Addendum to Arboricultural Report (009978) - Design Review – Brandon Park Shopping Centre

I advise the following in relation to the tree impact assessment undertaken with regard to the proposed Residential and Mixed Use developments in the northeast corner of Brandon Park Shopping Centre, in Wheelers Hill.

Figure 1. Edited extract of DA060 – Demolition ground plan (tree numbers added).

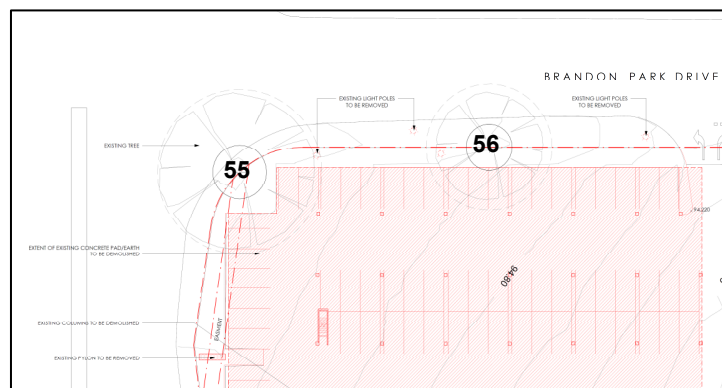
- a. **Demolition:** As shown in Figure 1, demolition includes removal of the existing carpark, including the asphalt road surface and the raised carpark structure. As shown in Images 1-2 and in Figure 1, the carpark kerb and asphalt surface are close to both trees, so there is a moderate possibility that tree roots exist here. It is therefore important that the demolition is undertaken in a root sensitive manner to protect any underlying roots from damage.

Figure 2. Edited extract of DA100A (proposed mezzanine plan). Tree points coloured according to arb rating; Bright green = High, Light green = Mod.A. Light blue circles = TPZs, magenta circles = SRZs.

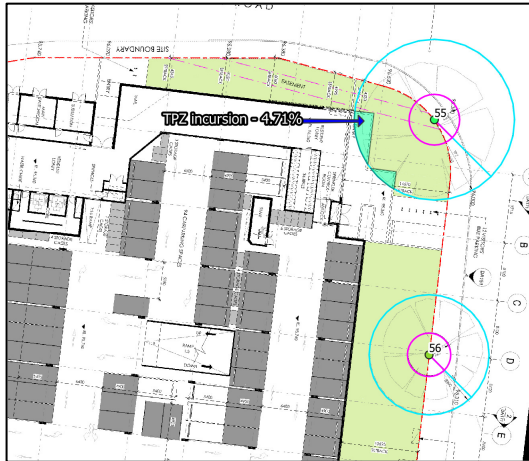
- b. **Ground floor:** As shown in Figure 2, the ground (lowest) floor of the proposed residential building would intercept the TPZ of Tree 55 by ~4.7%. This is considered minor TPZ encroachment under the Australian Standard (AS4970) and this level of incursion is not expected to impact the tree's ongoing viability or condition. It is noted in Figures 5&6, that fill is proposed between the new building and both tree stems. The following is recommended to prevent fill impacts to the tree root zone:
- i. The level of the existing permeable environment should remain unaltered.
 - ii. Fill over the existing asphalt area will likely be tolerated although this should be kept to a depth of <100mm within 5 metres of the trees.
 - iii. If a retaining wall is required to achieve this, the wall should be supported by isolated pegs or similar, i.e. a continuous strip footing should not be used.

Figure 5. Extract of DA183 (street interface section), relative to Tree 55.

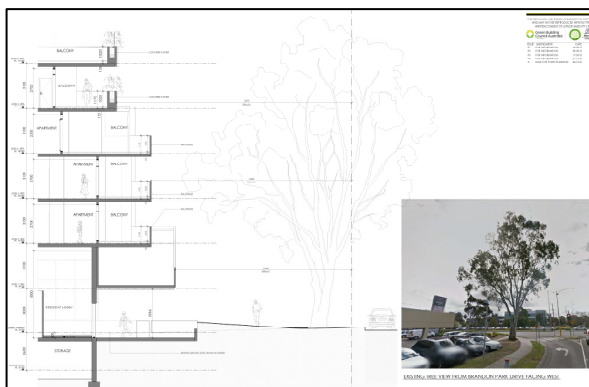
- c. Above ground floors:** Figures 5-9 indicate that there will be no physical conflict between the building and either tree crown although some minor pruning may be required, depending on construction requirements (e.g. scaffolding). The 'architectural canopy' on the corner of the building is the only area that may come into close proximity to the crown of Tree 55 during construction (as seen in Figures 8 & 9). If any pruning were required, it would be removal of one lower branch (<5% total live crown), which the tree would be expected to tolerate. Tree 56 is set back adequately from the proposed building and there would be no anticipated pruning requirements.

Figure 10. Edited extract of DA060 – Demolition ground floor plan (tree numbers added). Tree numbers colour coded according to arb. rating; light green = Mod.A, yellow = Mod.B, orange = Mod.C.

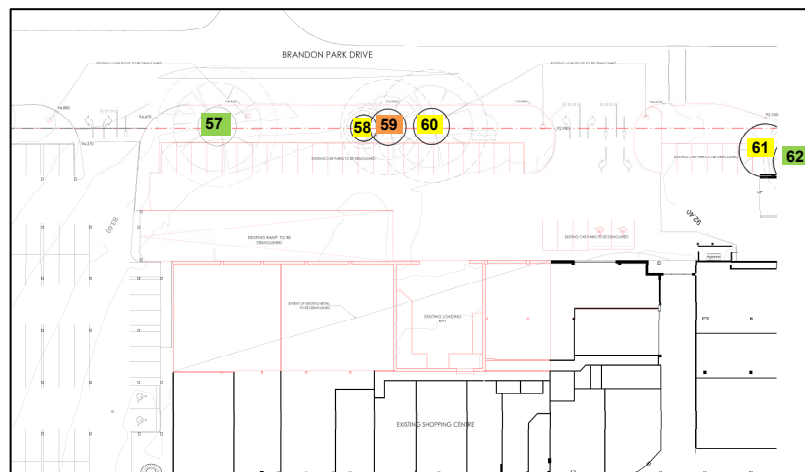
- a. **Demolition:** As shown in Figure 10, demolition includes removal of the existing carpark, including the asphalt road surface and kerbs along with existing ramp, loading bay and part of the retail building. As shown in Images 3-5 and in Figure 10, the carpark kerb and asphalt surface are close to all trees (aside from Tree 62), so there is a moderate possibility that tree roots exist here. It is therefore important that the demolition is undertaken in a root sensitive manner to protect any underlying roots from damage.

Figure 11. Extract of DA100 – proposed ground floor plan

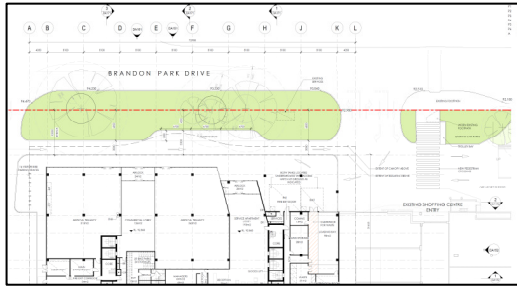
- b. **Ground floor:** As shown in Figures 11 & 12, the proposed ground floor plan will result in no additional TPZ encroachment into any of the five trees and will expand the permeable growing environment of all trees. Nevertheless, construction of the new road and waiting bays will take place within some TPZs so care needs to be taken to ensure any underlying roots are not damaged. It is noted in Figure 14, that fill is proposed between the waiting bays and the trees. The following is recommended to prevent fill impacts to the tree root zone:

- i. The level of the existing permeable environment should remain unaltered.
- ii. Fill over the existing asphalt area will likely be tolerated although this should be kept to a depth of <100mm within 5 metres of the tree.
- iii. If a retaining wall is required to achieve this, the wall should be supported by isolated pegs or similar, i.e. a continuous strip footing should not be used.

Figure 14. Extract of DA181 – Street interface section 1. Note tree silhouette (Tree 57) is in the foreground in this section so the furthest extent of the architectural canopy does not intercept the tree canopy (See DA101)

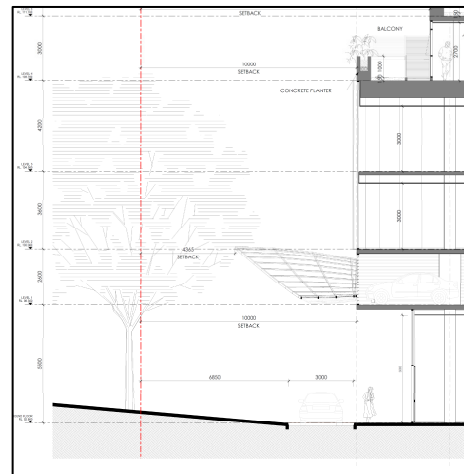
- c. **Above ground floors:** The section diagram at Figure 14 measures the relative setback of the building edge to the site boundary at ~10m. This should be sufficient space for construction activities to take place without requiring any canopy pruning. The only part of the design that comes closer is the architectural canopy extending from the first floor, although as shown in Figure 13, this is positioned outside the canopy of the larger trees so it is also not expected to necessitate any canopy pruning.
